An Bord Pleanála,
64 Marlborough St.
Rotunda,
Dublin 1.

RE : Dart + West+ Project . Reference 314232 . Interested Party not notified and excluded from process.

My Name is Patrick Comerford and I wish lodge an objection and make observations in relation to the planning application submitted by Dart + West for planning permission for new Railway lines and Depot located between Maynooth & Kilcock. The project in its current form (your application reference 314232) is unacceptable and the application is invalid in so far as it has failed to adhere to the most basic planning regulation and furthermore I want to formally make a request for an Oral hearing.

Figure 1. Dart + West Proposed CPO in grey at Ballycurraghan with new entrance to Land at Ballycurraghan marked in yellow

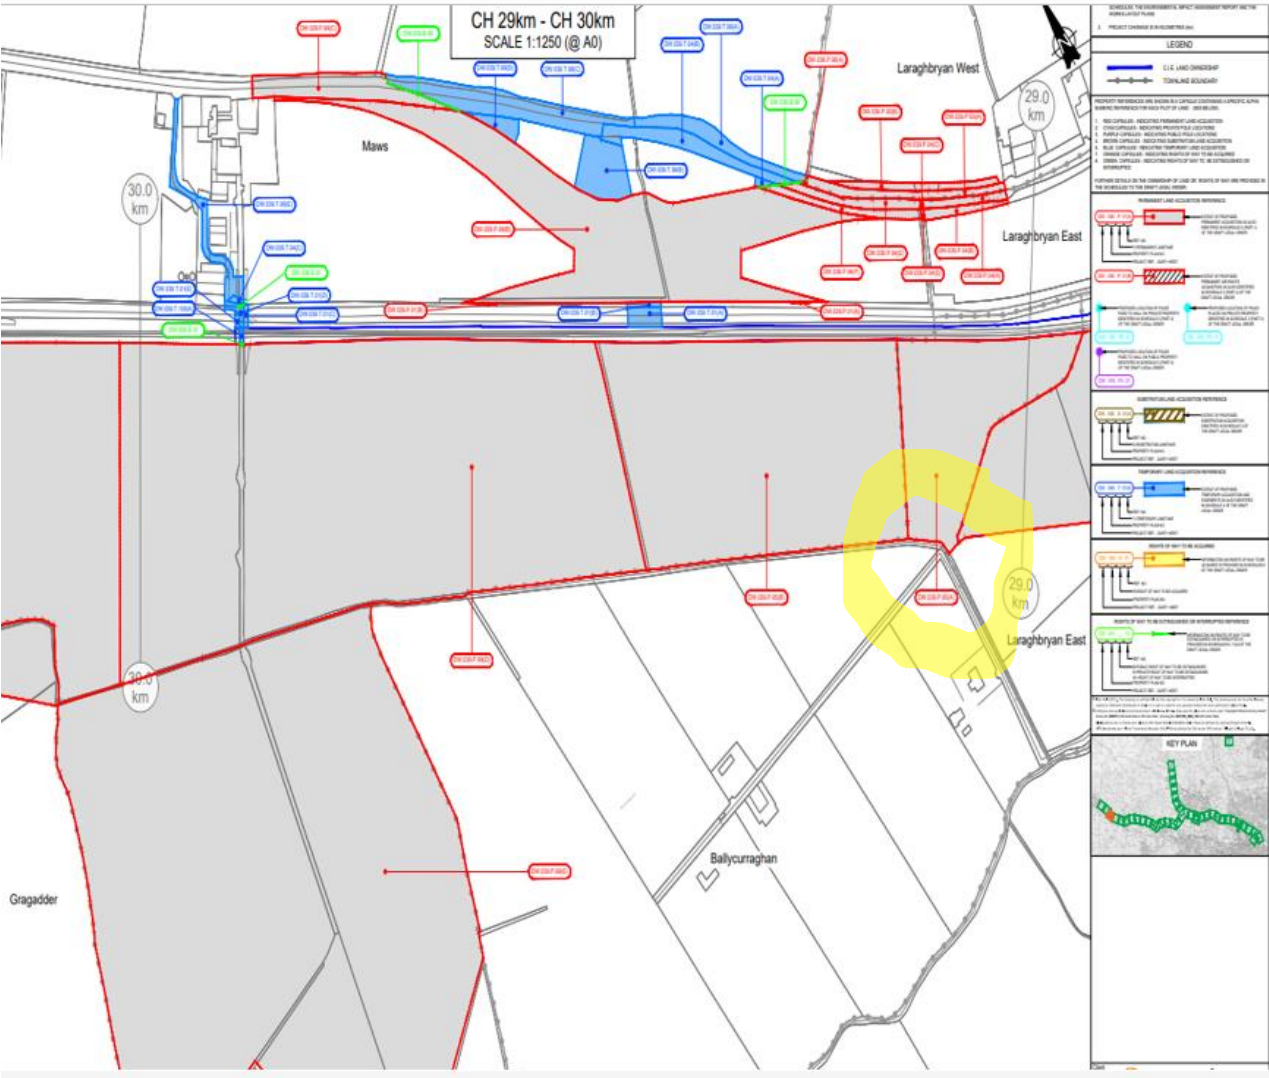
In relation to the second entrance, you will see from Figure 1. Below. Dart + West Proposed CPO at Ballycurraghan with new entrance to Land at Ballycurraghan marked in yellow see out below. Figure 2 show a picture of the proposed work at the depot with alteration to private laneway at Ballycurraghan circled in yellow. Clearly this work should have been included as part of the Railway order as private rights of way and private road is being altered. I can say that Irish rail or their consultants did not notify or engage with me in relation to this work. In fact, the contrary is true in so far as I was told by a Dart West Employee that the proposed works has notifying to do with me. Clearly this is not the case. Figure 3 shows Land at Ballycurraghan including right of way over roadway to Ballycurraghan marked in yellow with area of proposed alteration and entrance to Laneway marked in blue.

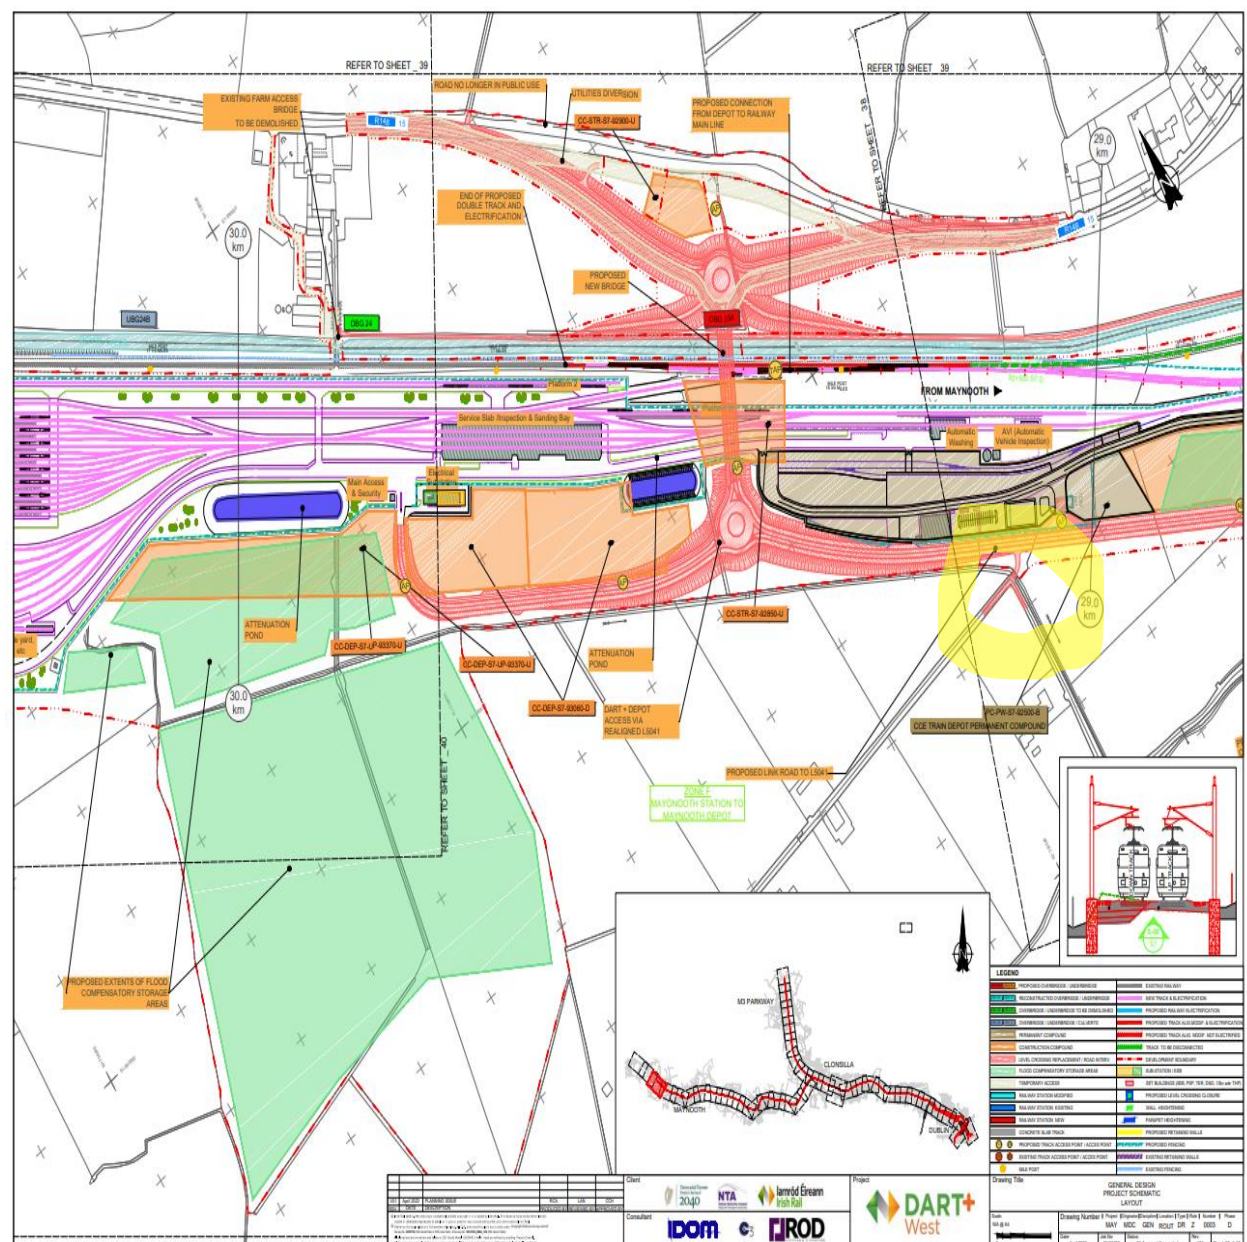
Figure 2 show a picture of the proposed work at the depot with alteration to private laneway at Ballycurraghan circled in yellow. Clearly this work should have been included as part of the Railway order as a private right of way and a private road is being altered. Neither Irish rail or their consultants notified or engage with me in relation to this work

Picture of Junction for Ballycurraghan Road and Jacksons Bridge

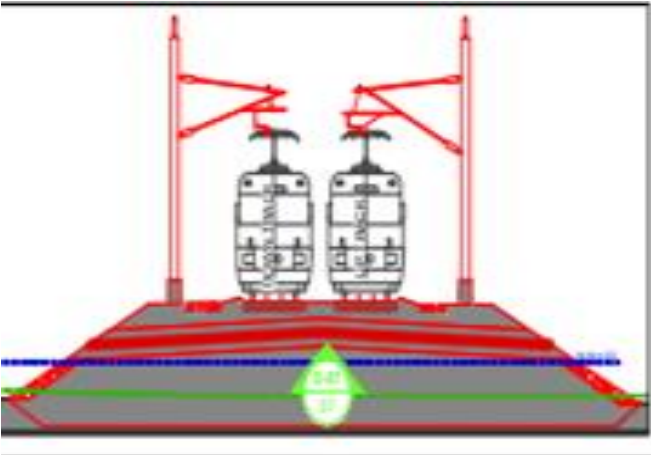
Levels at Jacksons Bridge and Train Levels Showing train line actual train level 1.4 m above flood plain average or just below level of hedge.

Blue line in picture above represents 60.36 which 1.40 above Ballycurraghan Lane level which is going to visually have a serious effect on the area.

Picture 5 . Receding Floodwaters at Jacksons Bridge / Ballycurraghan November 2017

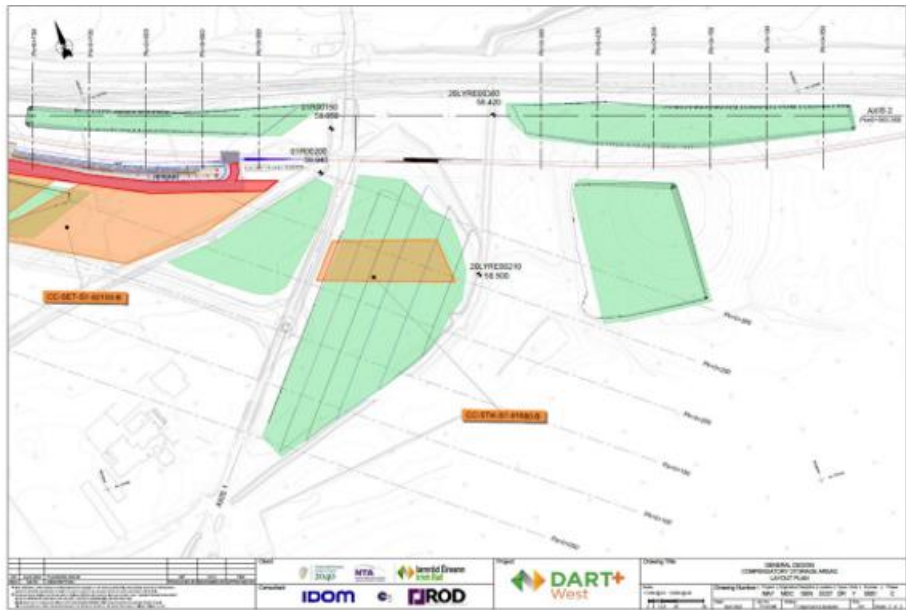
Above please see the area that it is allocated to compensatory flooding capacity. As you can see this area is subjected to severe flooding already. The Water table level is extremely high so any excavation is only going to expose ground water. In my view there will be no additional compensatory flooding capacity provided.

Figure 5-356 Millfarm compounds and haulage route

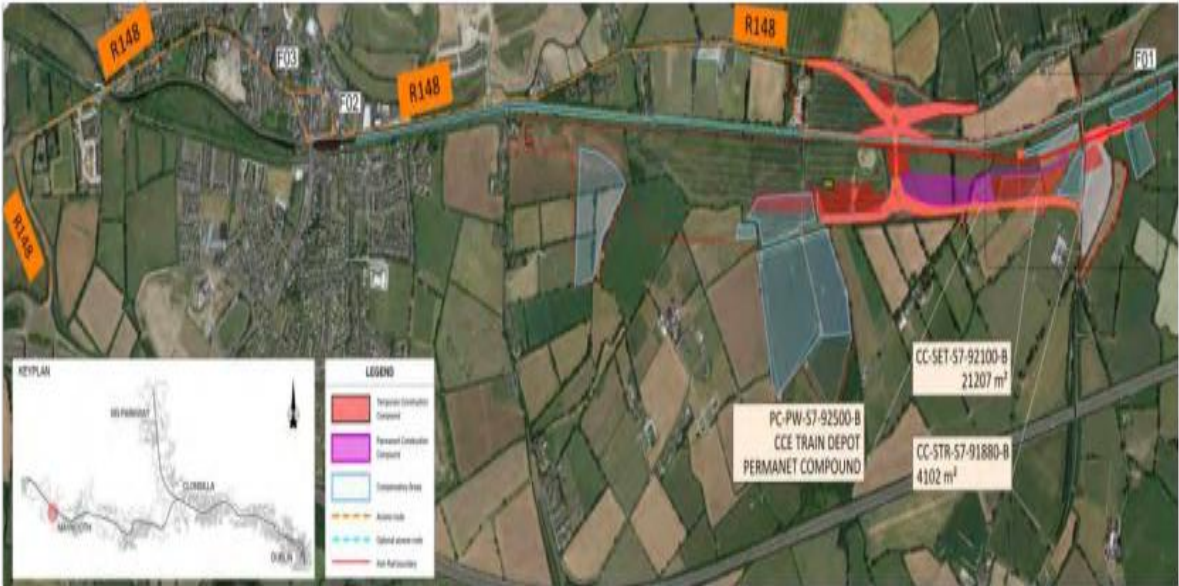
Figure 5-356 Millfarm storage and compounds will be accessed through Kilcock bringing all addition traffic and congestion associated with this to Kilcock. If this project proceeds there is an argument to provide additional access to in both directions M4 from L5041

Figure 5-372 OBG23A Construction compounds and haulage routes

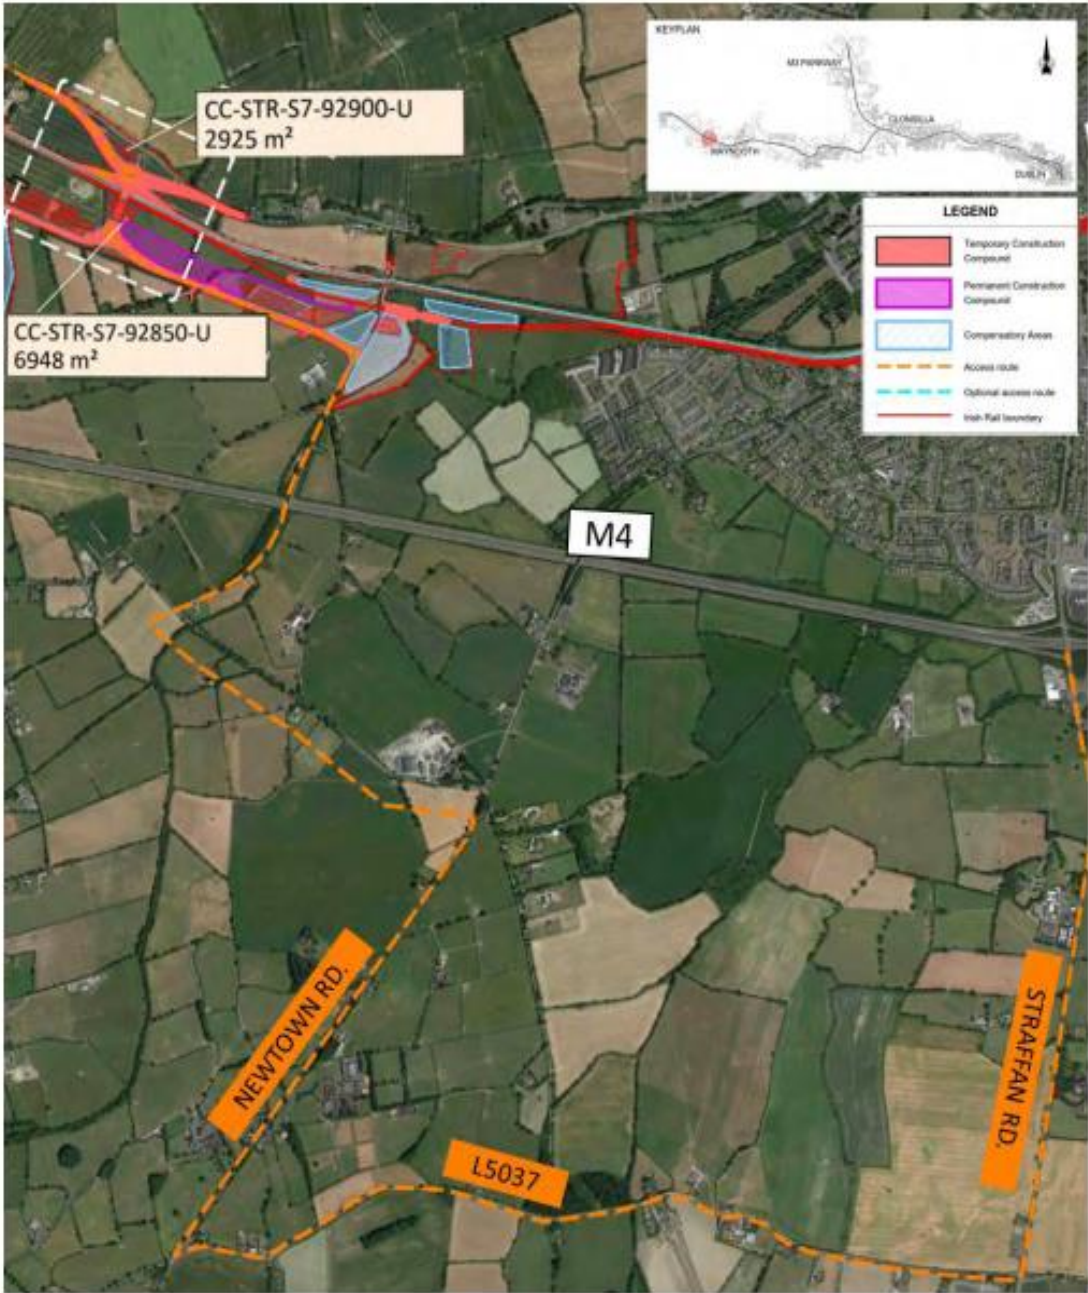
OG23A projected to take 12 months to complete, and Newtown Road is proposed to take traffic from the south which is going to cause great difficult for residents .

Alteration to Private Laneway Ballycurraghan

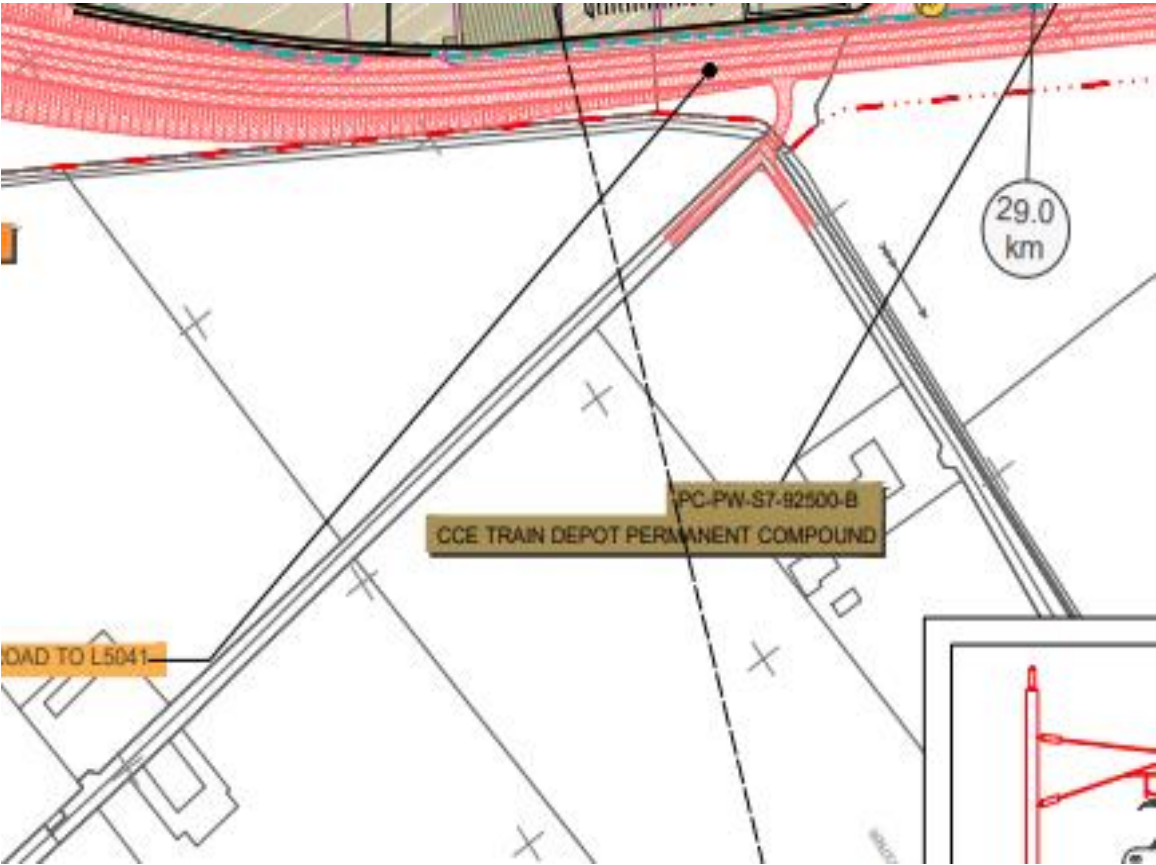
Proposed alteration to private lane at Ballycurraghan in contravention of proper procedure and railway orders

Appendix A20.4
Geophysical Survey
Report

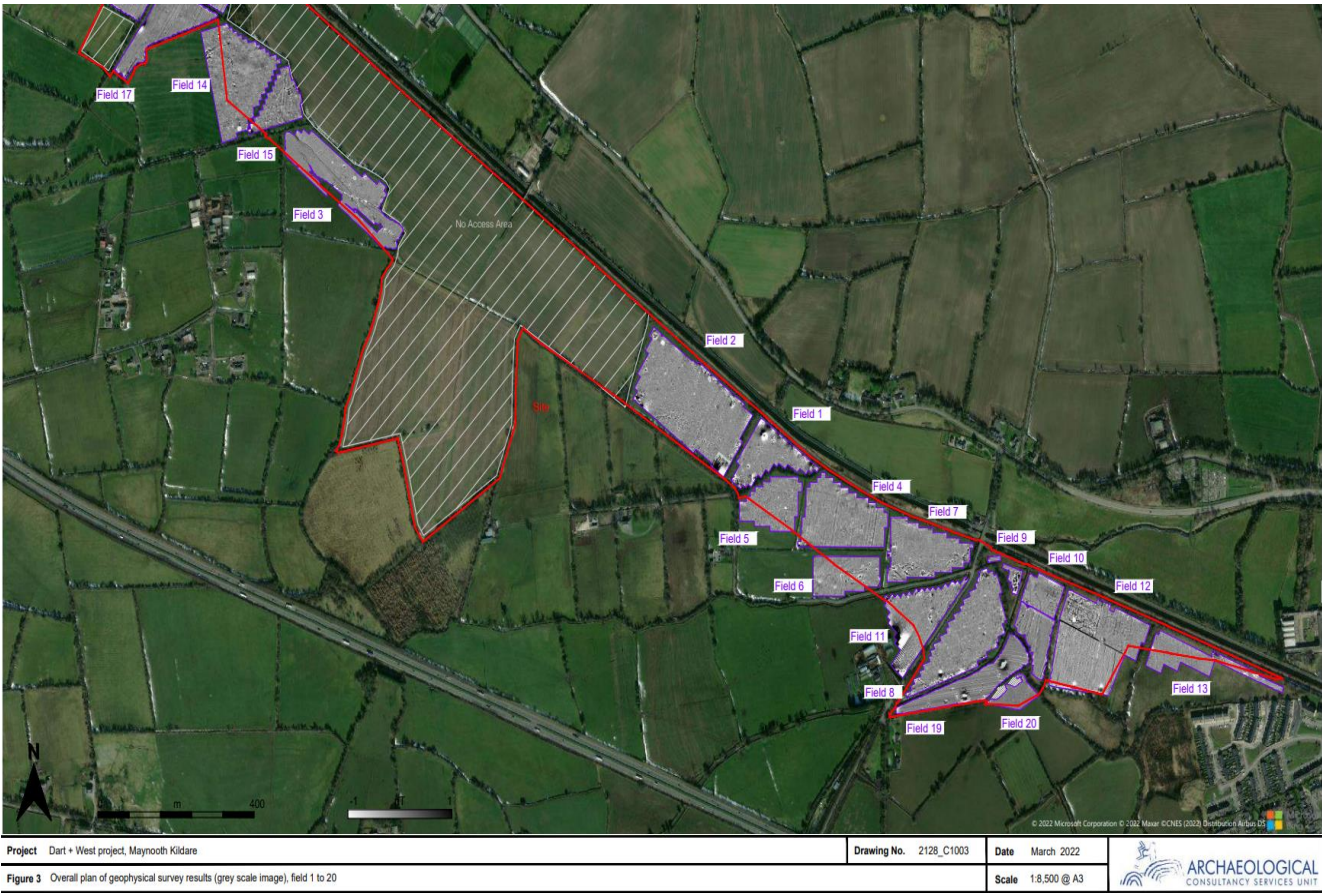
It's important to note here that the proposed Entrance to Ballycurraghan from link road L 5041 has not identified the cut-stone bridge and large tracts of the proposed depot site have not been investigated at all.

Again, it's important to note here that the cold stone bridge mentioned above has been surveyed but not included as part of this report. I believe this breach dates back to construction of Jacksons bridge which is a protected structure
